June 15, 2021

Re: Mine Operating Permit Application I-002329
Luck Stone Corporation
Fairfield I-77 Quarry Fairfield County

FIG. 6: LIMITED HYDROGEOLOGIC ASSESSMENT SUPPLY WELL LOCATION MAP

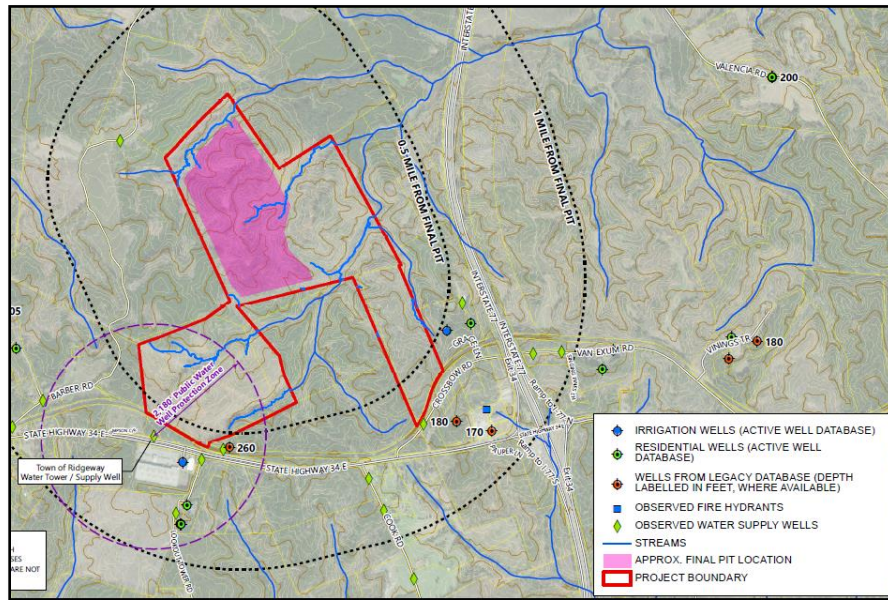
introduction of residual nitrates into the groundwater system. This permit should be denied considering that this project is so close to the public water supply. In Luck's own materials, it states: "One public water well with a 2,180-foot radius PWSW Protection Zone is located approximately 3,200 feet southwest of the proposed mine pit. Multiple water supply wells included in the reviewed database, or presumed wells observed by reconnaissance, are located generally greater than 0.5-mile and less than 1-mile from the proposed mine area." *Limited Hydrogeologic Assessment*, p. 9. The quarry's proximity to the public water supply well (#SC2010002) is concerning. This well is supposed to have a defined 2,180-foot radius protection zone; however, the permit boundaries encroach on this zone and Luck itself has stated the distance from the pit to the well is approximately 3,200 feet.³⁴

The mine's proximity to a public drinking source, combined with a lack of information on how the public will be kept safe must be considered by DHEC when reviewing well permits, NPDES permits, and mining permits. Luck Stone's submission also includes an 8-page *Groundwater Monitoring Plan* which purports "to measure static groundwater levels on a regular basis to establish a pre-mining baseline for groundwater levels and to document changes to groundwater levels during the mining operations;" however, no information about the quantity of groundwater required for their proposed activities is provided in the application where the applicant is supposed to describe their groundwater pumping activities:
